### **JSP23-38 VARSITY LINCOLN AUTO SHOP ADDITION**

Consideration of Varsity Lincoln Auto Shop Addition for Preliminary Site Plan and Stormwater Management Plan approval. The subject property contains 1.14 acres and is located south of Grand River Avenue, on the east side of Wixom Road, in Section 17. The applicant is proposing to add on to the front of an existing auto service shop to add a 1,130 square-foot display, office, and sales area. Parking lot and landscaping improvements are proposed in addition to a sidewalk along Grand River Avenue.

# PLAN REVIEW CENTER REPORT

**Review Date:** December 11, 2023  
**Review Type:** Combined Preliminary and Final Site Plan  
**Project Name:** JSP23-38 Varsity Lincoln Auto Shop Addition  
**Location:** 50-22-17-101-007  
**Plan Date:** October 26, 2023  
**Prepared by:** James Hill, Planner  
**email:** [jhill@cityofnovi.org](mailto:jhill@cityofnovi.org) ; **Phone:** (248)-347-0547

**sheet index**  
 LS-1 LANDSCAPE PLANTING DETAIL  
 LS-2 NOTES, PLANTING DETAILS & SOD, SEEDING REFERENCE PLAN

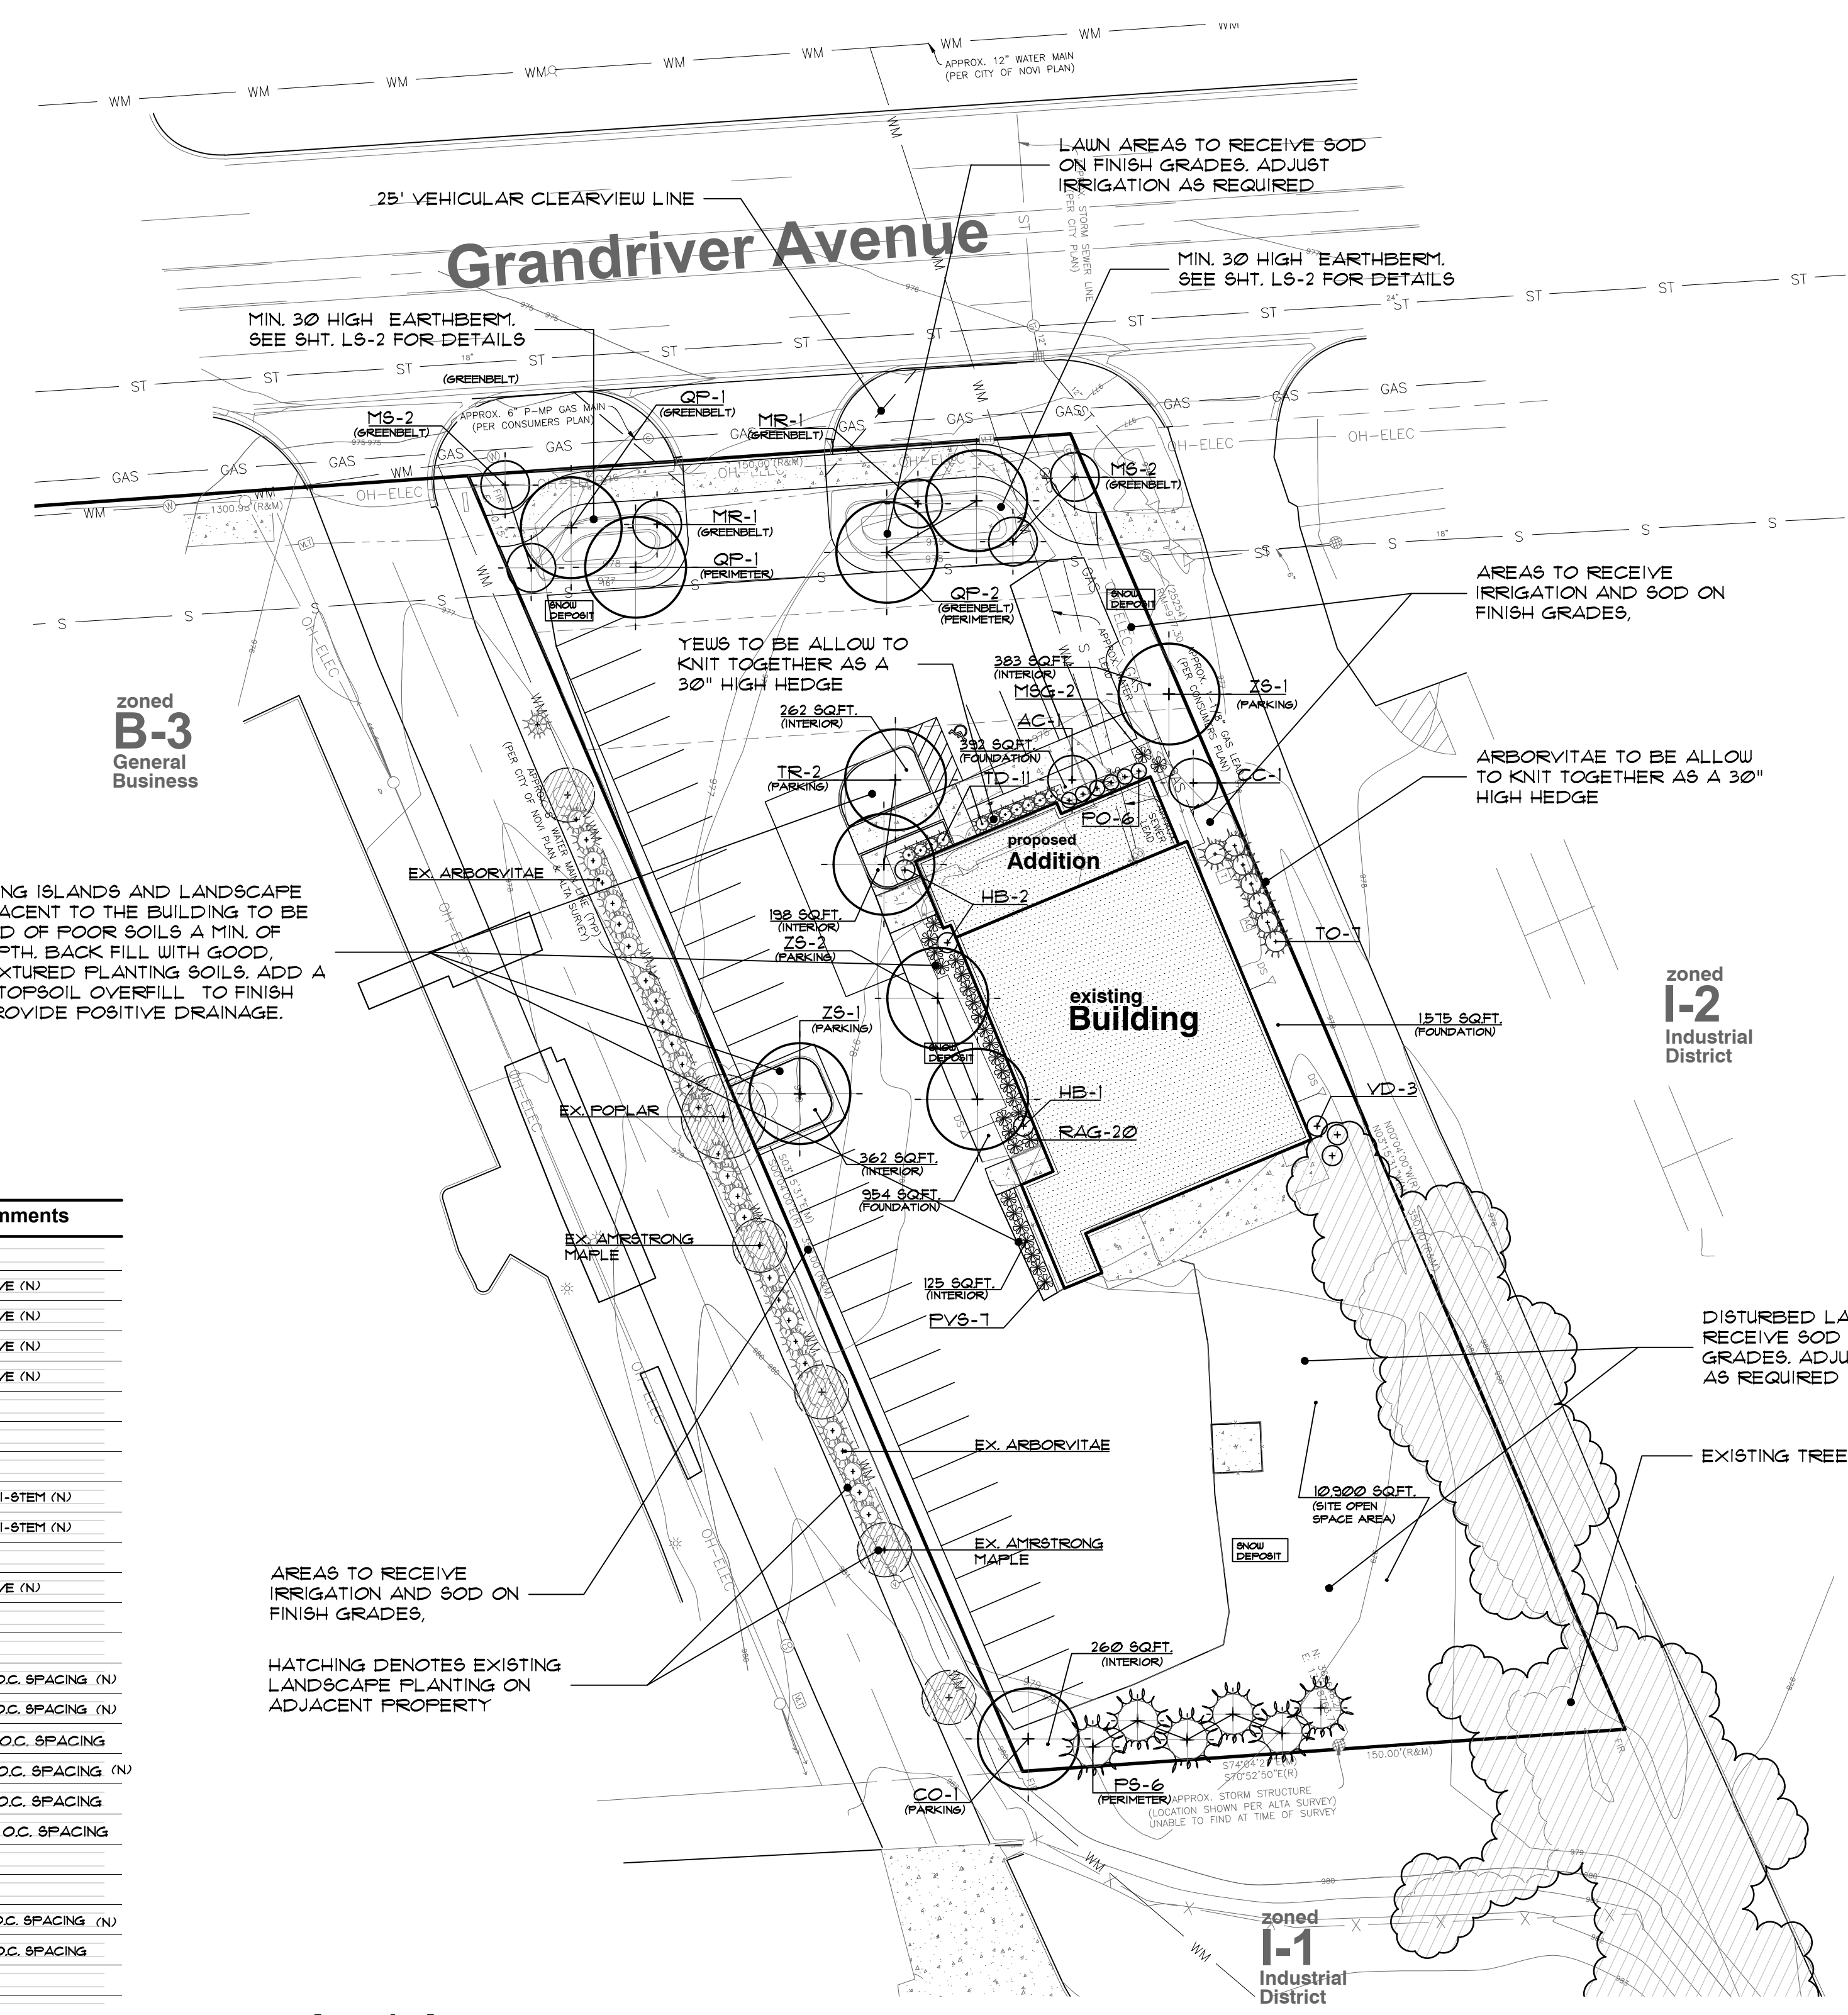
Comment: Please add the required screening around the transformer per the detail on Sheet LS-2.

Comment: 1) Please change the time period for replacement to 3 months (from notes on both sheets LS-1 and LS-2.  
2) In the City of Novi Landscape Note #16 on sheet LS-2, please remove the words “on three sides (min).”  
3) In the summary text block at the end for the City of Novi Landscape Notes on sheet LS-2, please change 2509 to 5.5.  
**The note revisions requested above will be completed on sheets LS-1 and LS-2.**

Comment: Please add note on the plan view near property line (referring to not planting within 4 feet of the property line.)  
**Note will be added on sheet LS-1.**
